D 112 E

2220 Z000

D 112 2220 Z 0001, -2220 Z 0002-**A:** first production run**B:** current production

Stand adapter / Stativanschluss

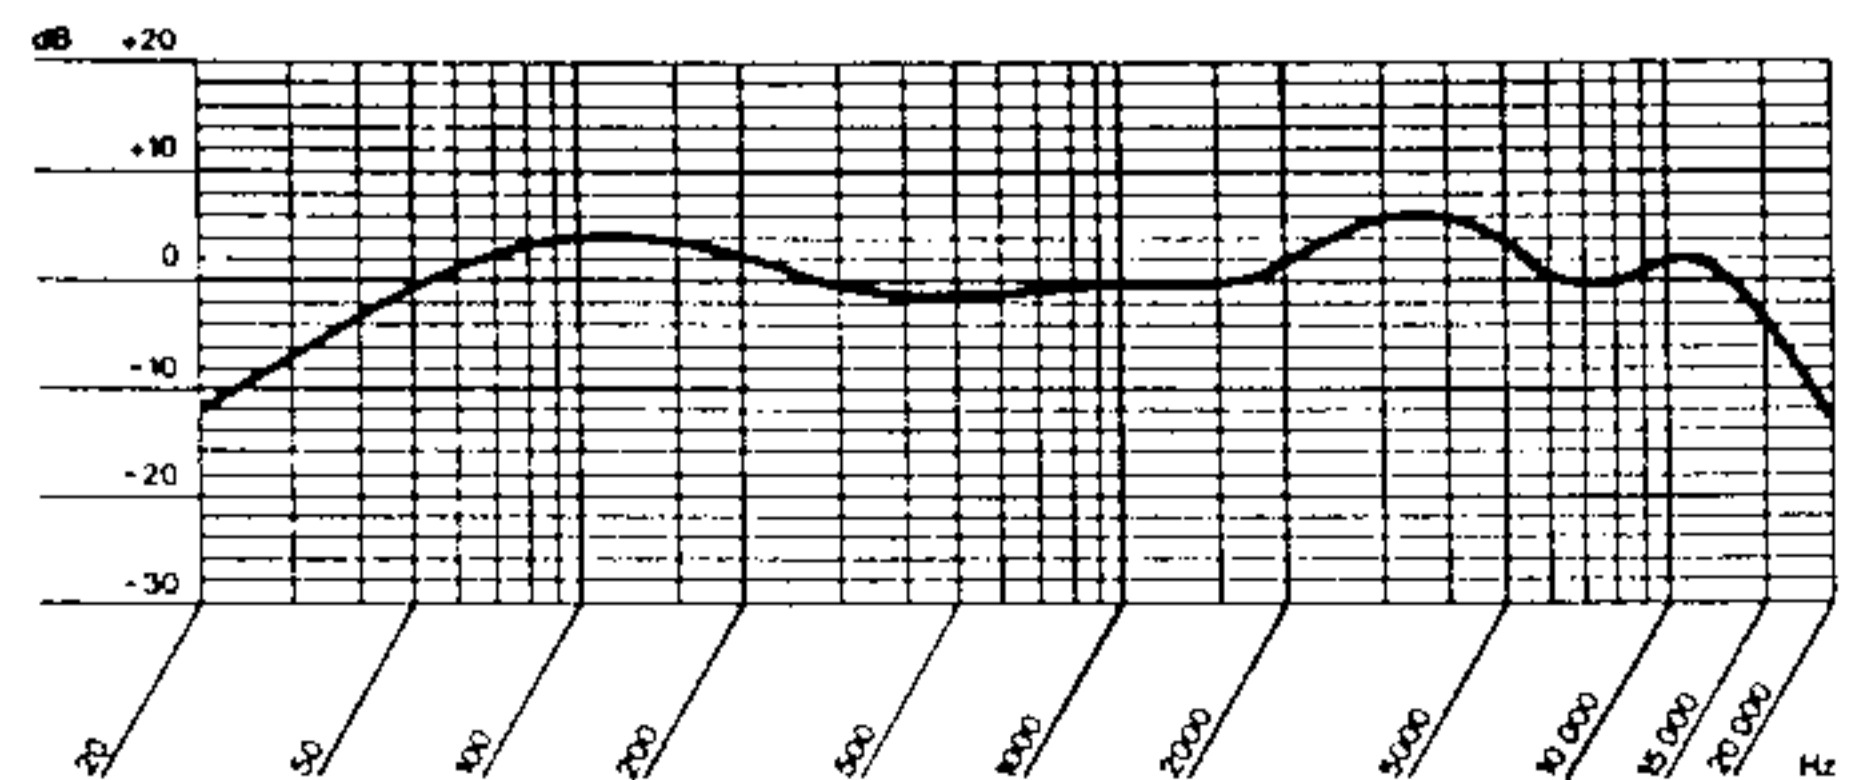
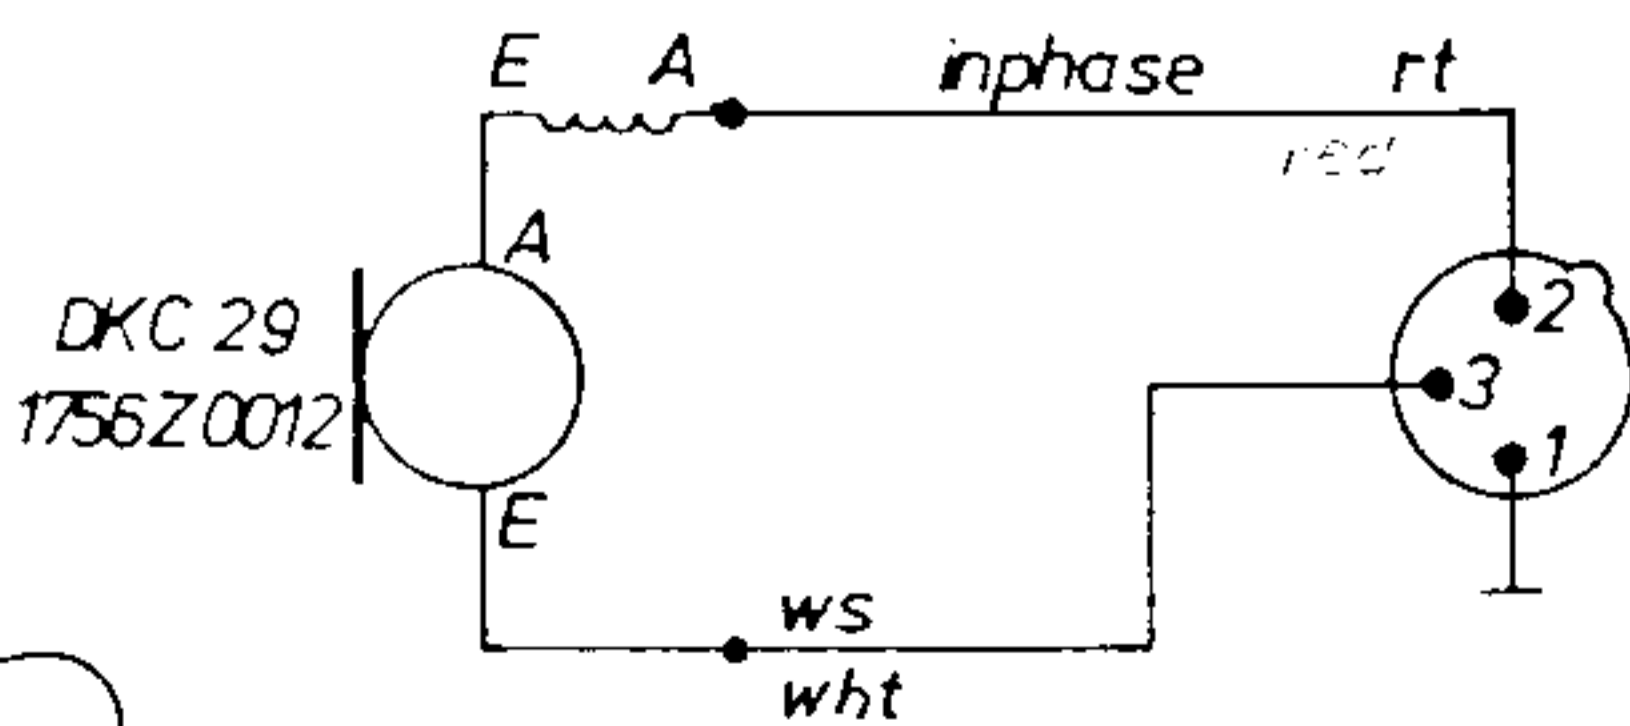
Former Version/Früher verwendbare Version:

SA40 6001H0311 available as a service item / Serviceteil

Recent Version/Derzeit verwendbare Version:

SA60 6001H6001 available as a sales item/Vertriebsware

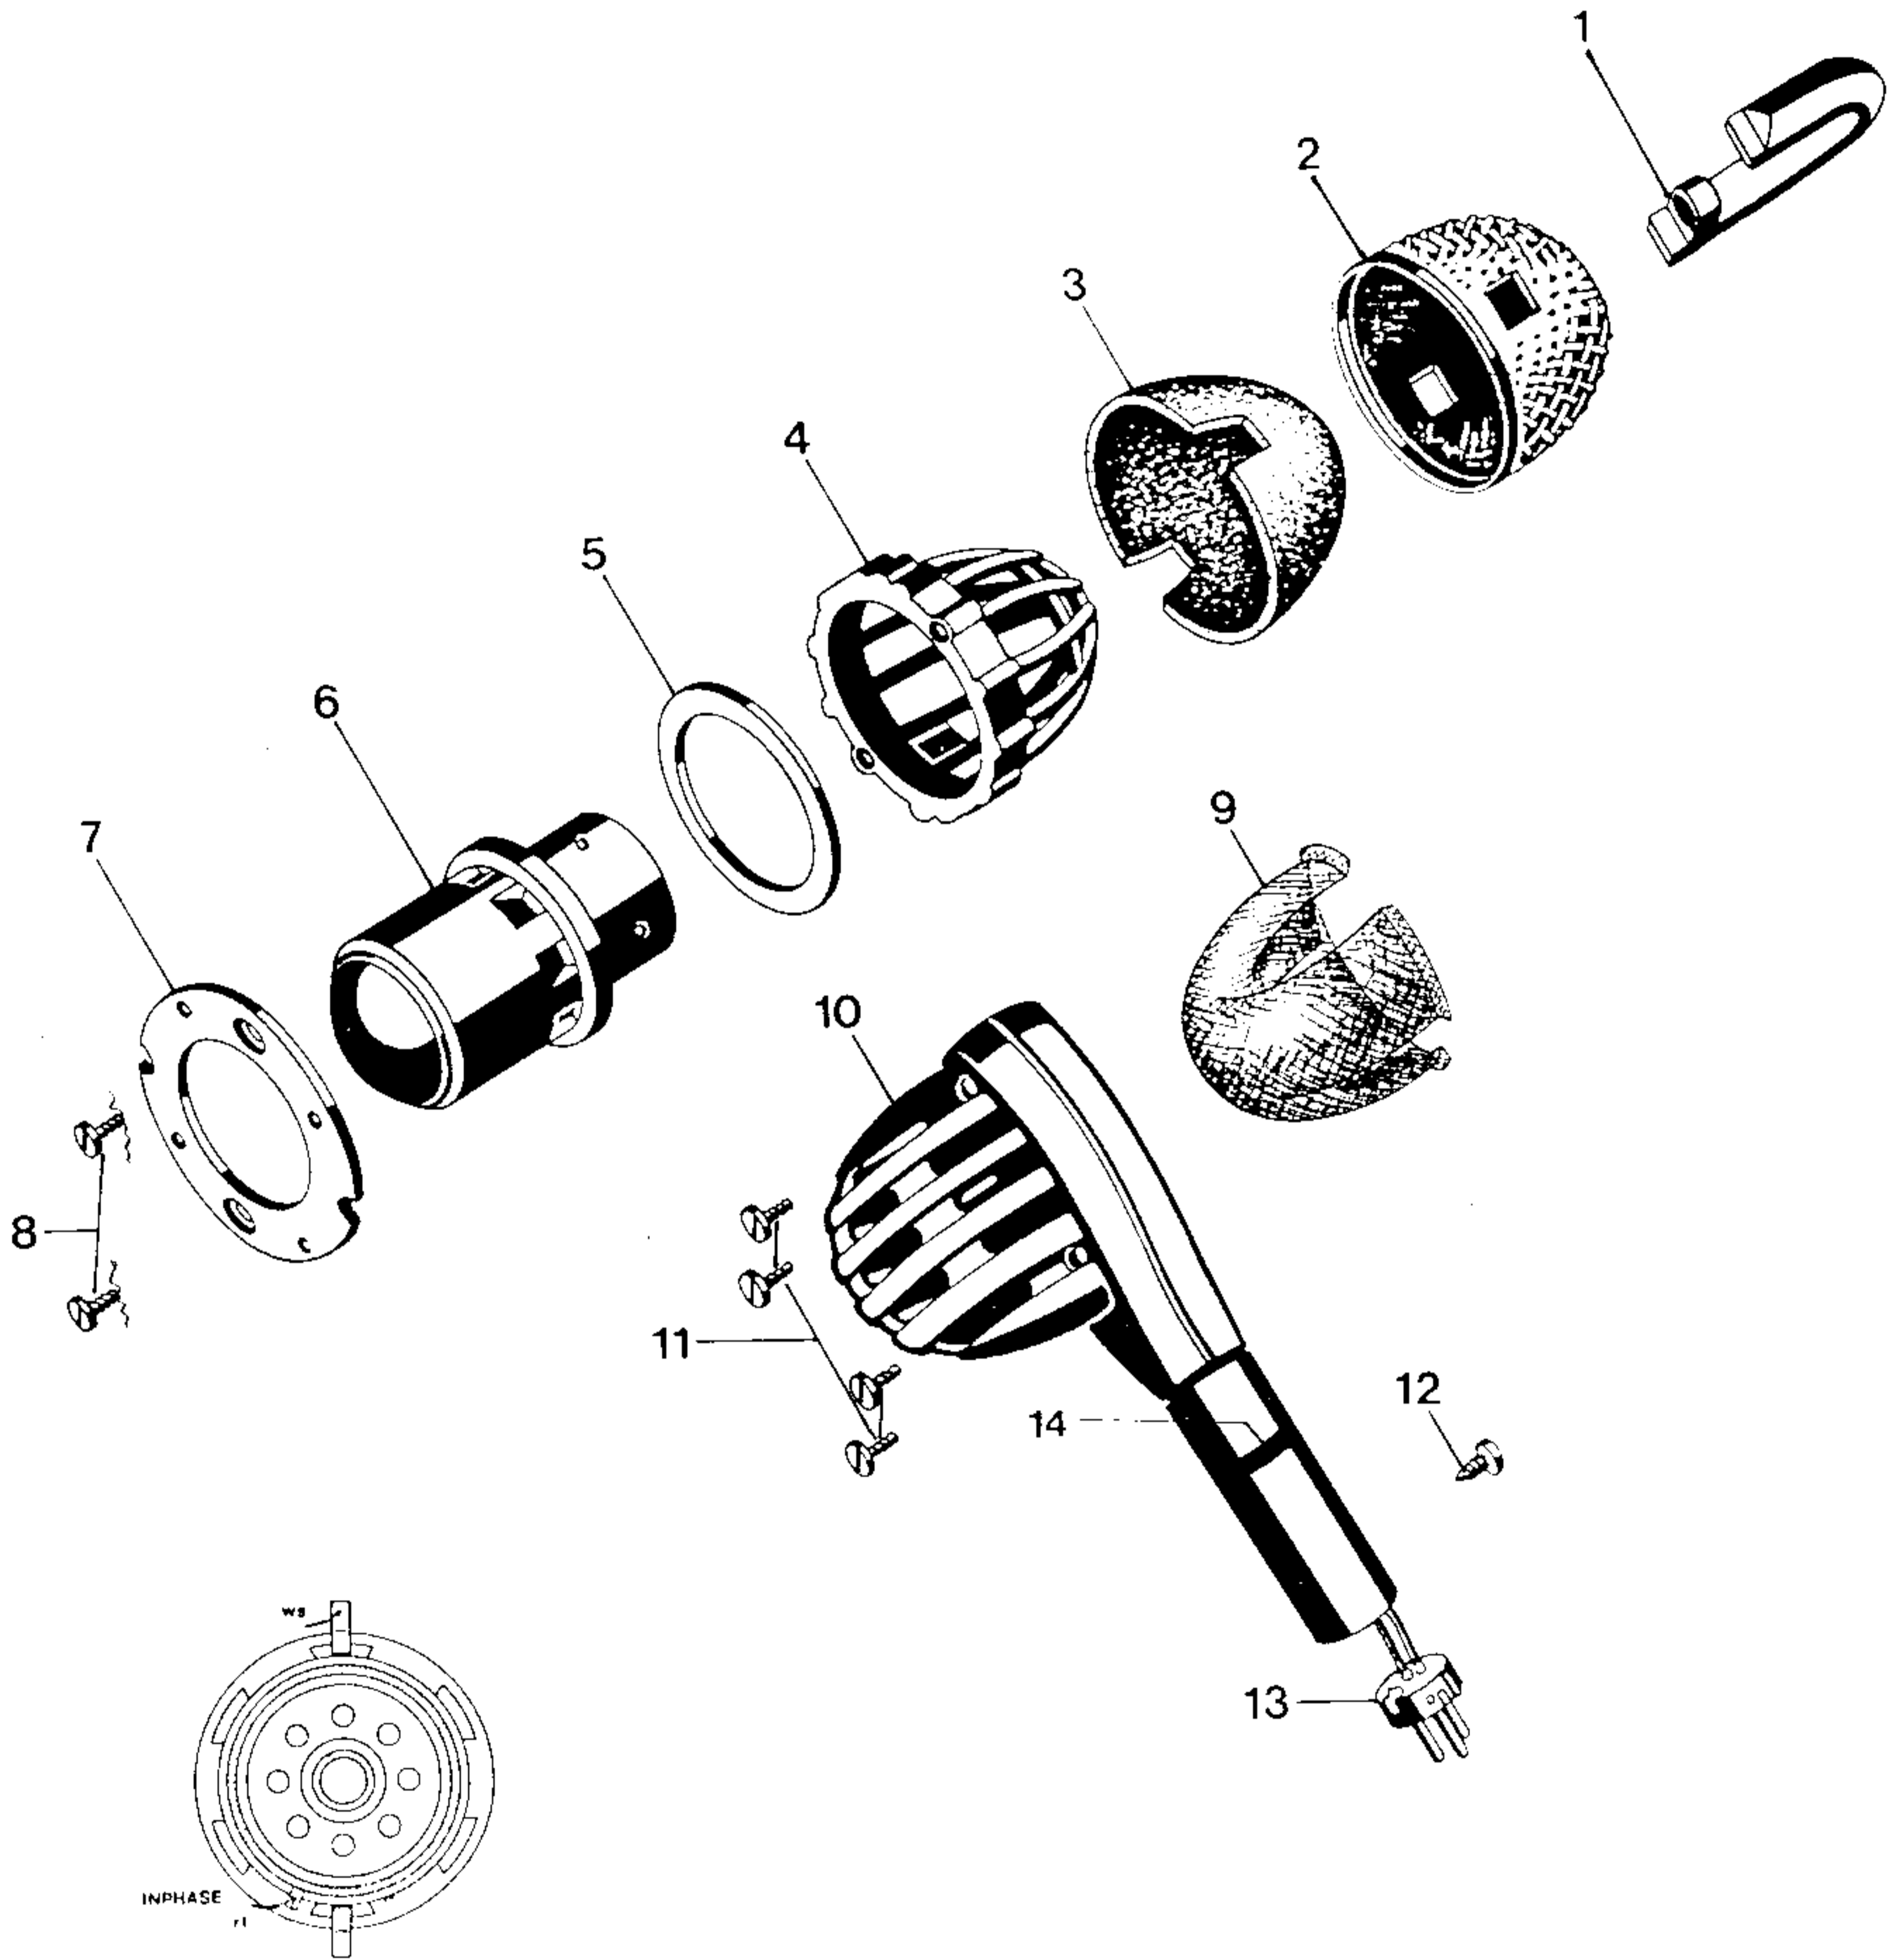
Neuerdings wird der Bügel 1 mit selbstschneidenden Schrauben (8) befestigt. Zum alten Bügel 2220M0301 mit Gewindeeinsätzen gehören die Schrauben 0084D3020, zur neuen Bügelversion 2220Z0901 die Schrauben 0099N3004. Ebenso wurden die Schrauben 11 auf selbstschneidende Versionen umgestellt. Teil 0099N3000 war eine Zwischenlösung. Gleichzeitig wurde auch der Ring 7 von 2220Z1101 auf 2220Z1201 geändert.

When assembling a dismantled D 112, the plug insert 13 has to be removed. The litz wires have to be tightened. Then the microphone can be put together. Only after that the plug can be remounted. This procedure prevents crushing of litz wires between housing 10 and ring 7. Microphones returned with errors like "hum", "noisy", "crackling sound" will most likely have the litz wires damaged. In that case please test performance of microphone with attached phantom powering. This will reveal any shortcircuit to the housing.

Recently ring 1 is fixed with selftapping screws. Screws 0084D3020 belong to the former ring version 2220M0301 with metal thread inserts, while for the new ring 2220Z0901 screws 0099N3004 are necessary. Also screws 11 have been changed to selftapping versions (0099N3000 was an intermediate variation). At the same time the ring 7 was modified (2220Z1201 instead of 2220Z1101).
